BWROG HUMAN FACTORS ENGINEERING - CONTROL ROOM SURVEY SUPPLEMENT

In response to recently formulated regulatory requirements for design reviews of nuclear power plant control rooms (NUREG-0660, NUREG-0700), Cleveland Electric Illuminating Company has undertaken a preliminary human factors evaluation of the Perry control panels. This one week review was performed by operations and engineering personnel from three utilities, two human factors consultants, and a representative from General Electric Company. General conclusions of the survey team are as follows:

PHOTO #31

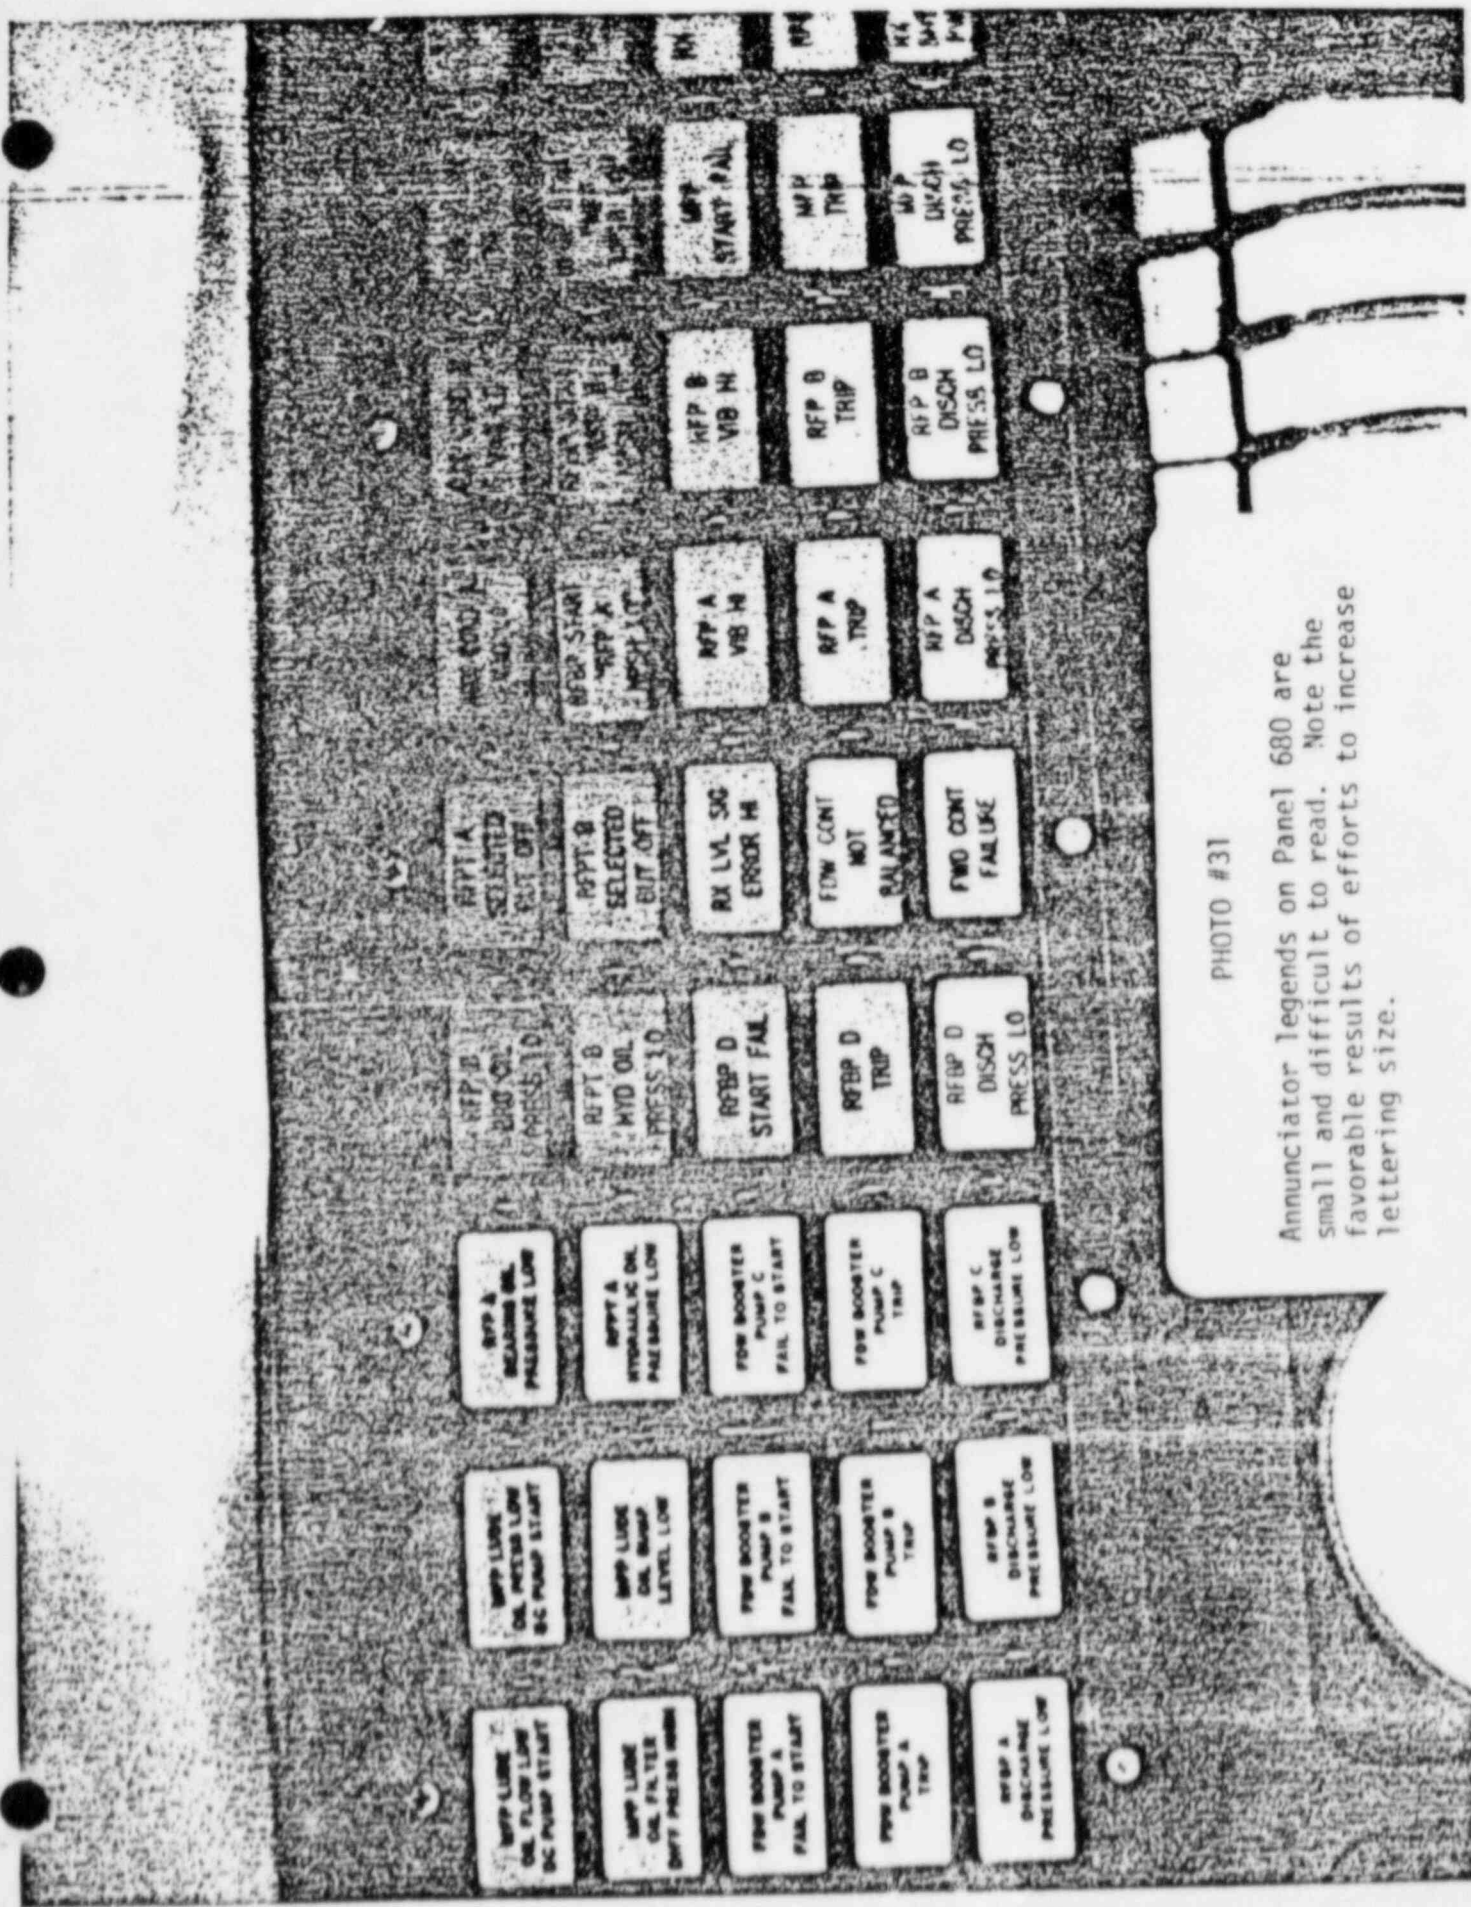
Annunciator legends on Panel 680 are small and difficult to read. Note the favorable results of efforts to increase lettering size.

PHOTO #33

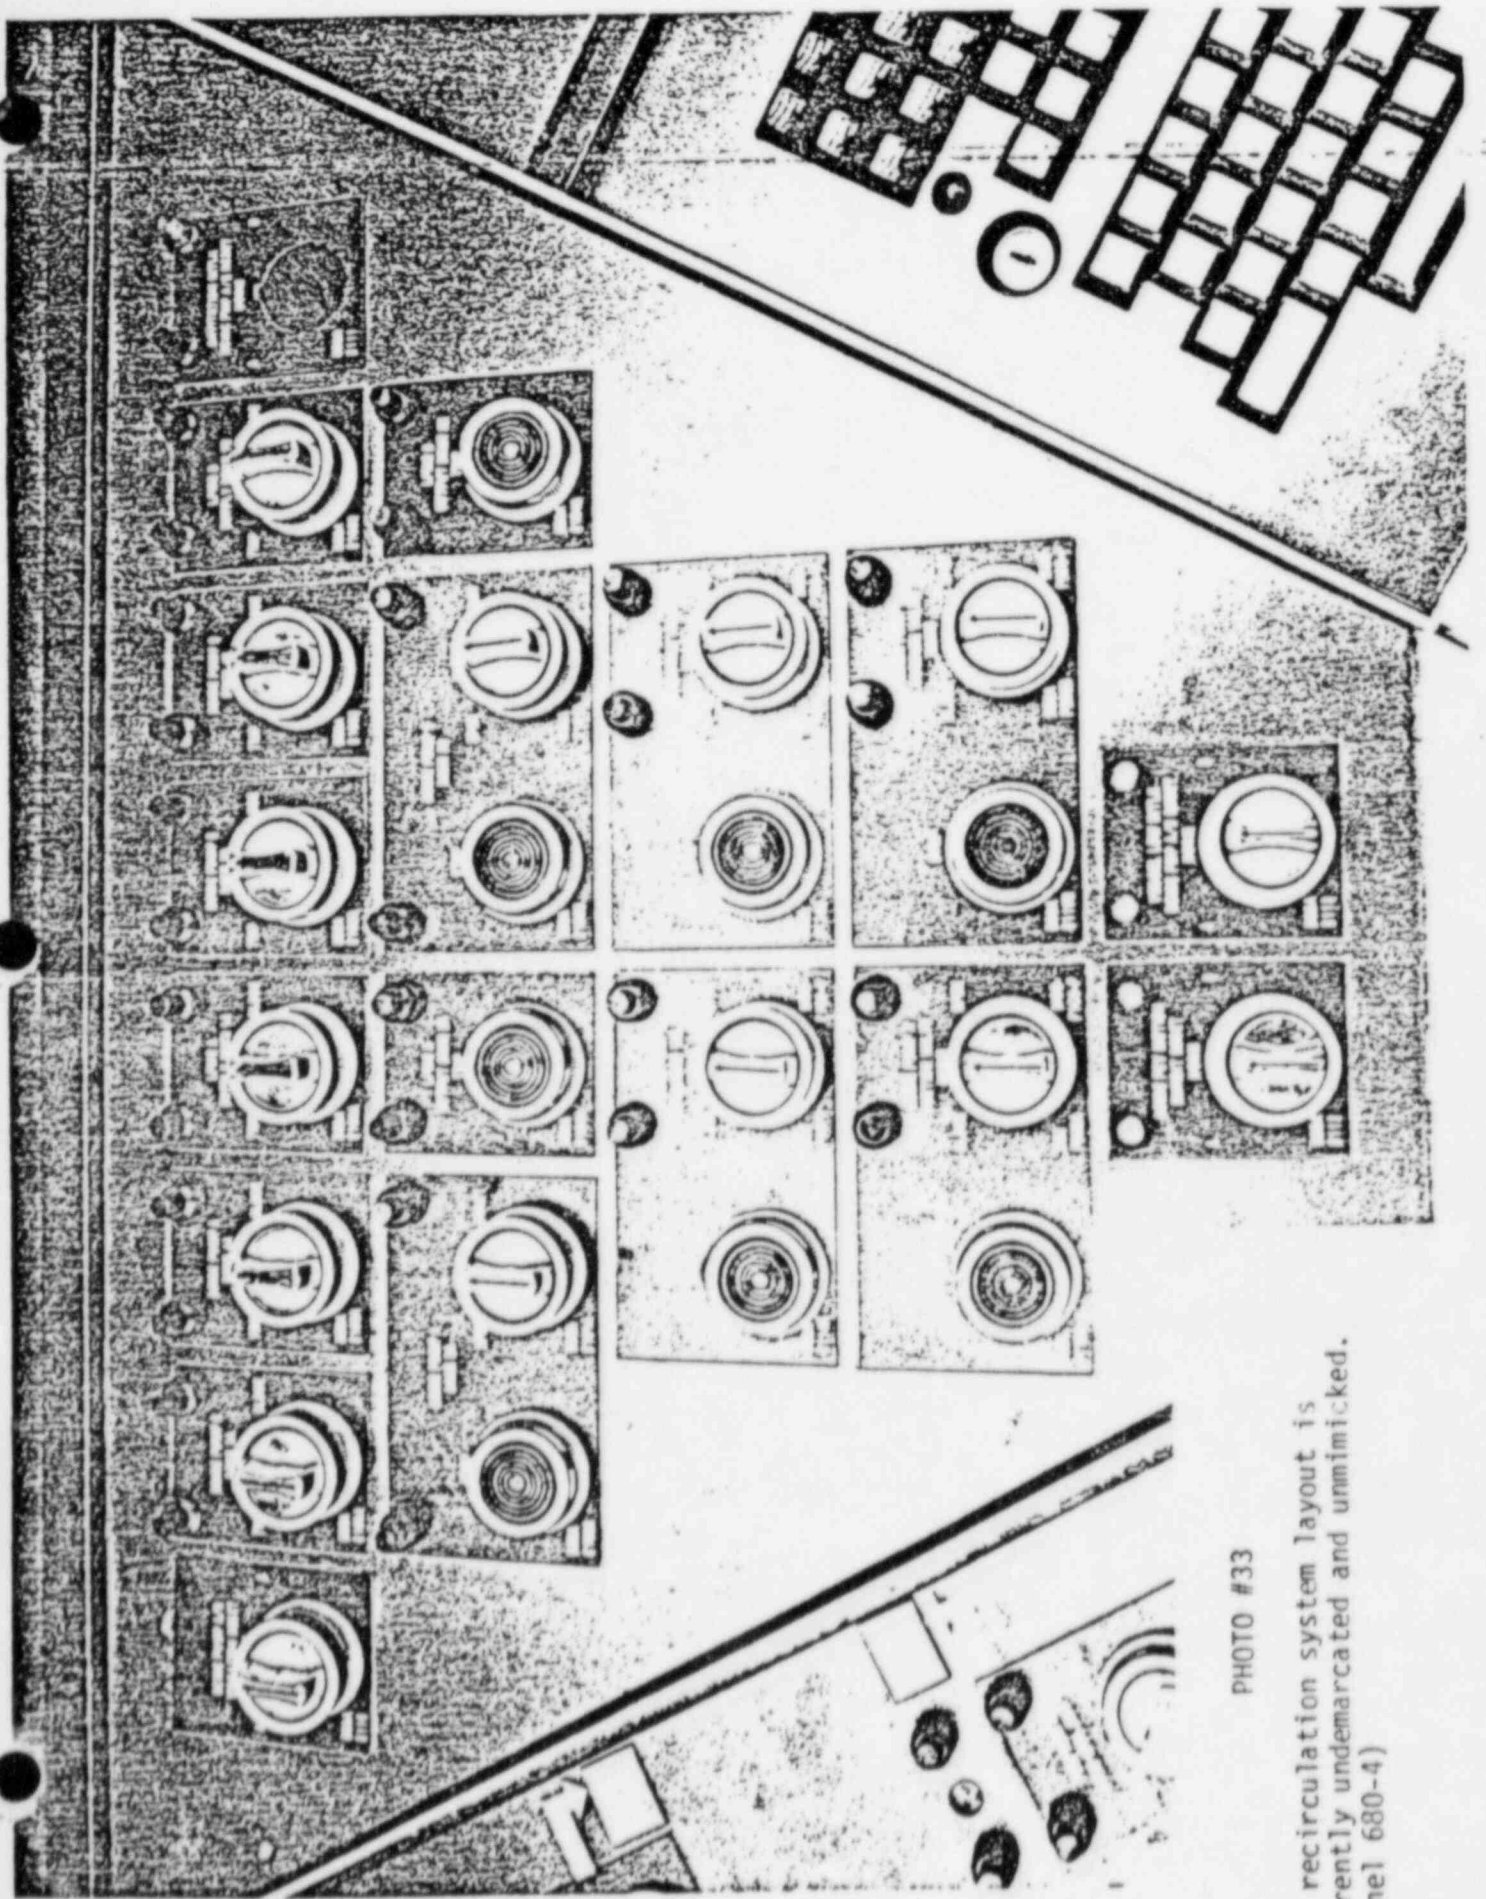
The recirculation system layout is currently undemarcated and unmimicked. (Panel 680-4)

PHOTO #41

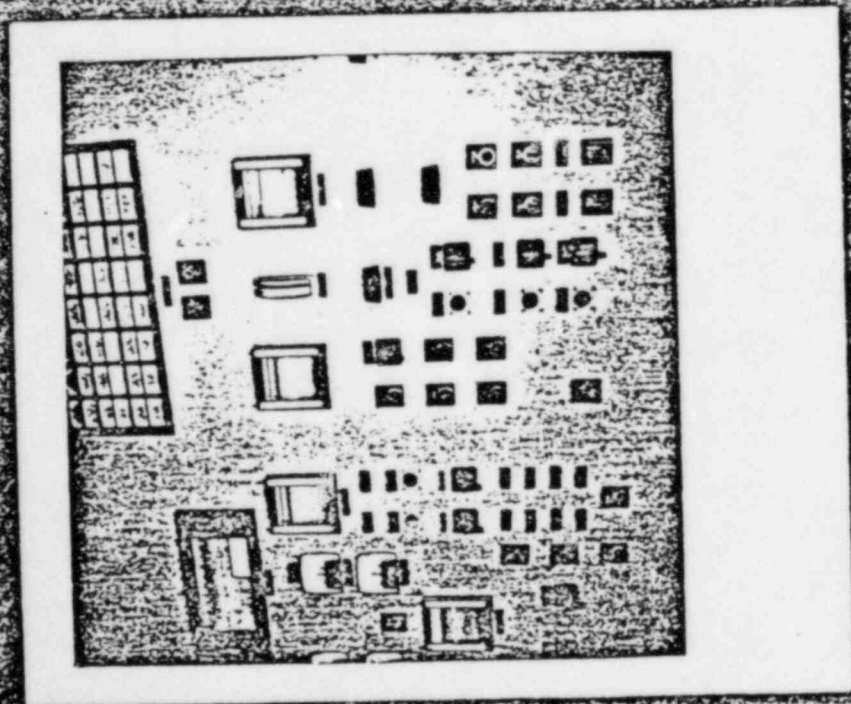
Demarcation lines could be used to subdivide Panel 845.

PHOTO #46

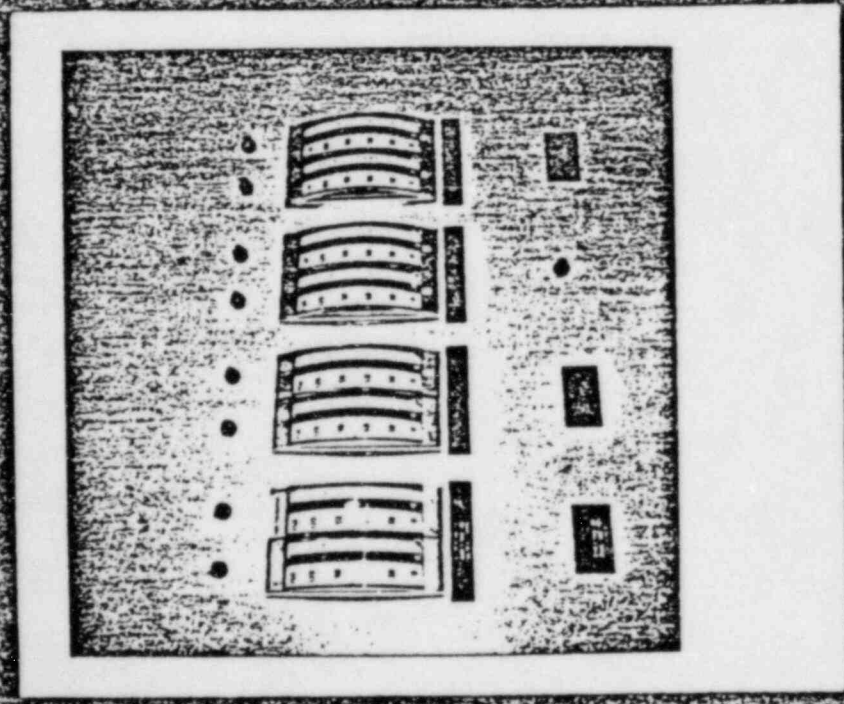
Unlabeled indicating lights on Panel 622.

PHOTO #54

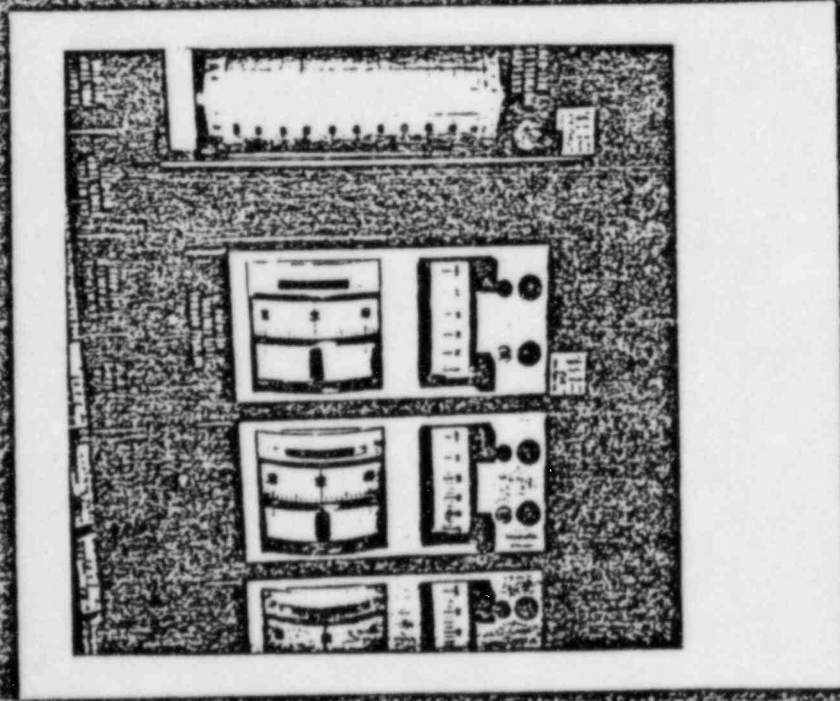
"0" on the hotwell level controller means the dump valve is full open and the fill valve full closed. "100" indicates the dump valve is full closed, the fill valve full open. At "50", each is 50% open.
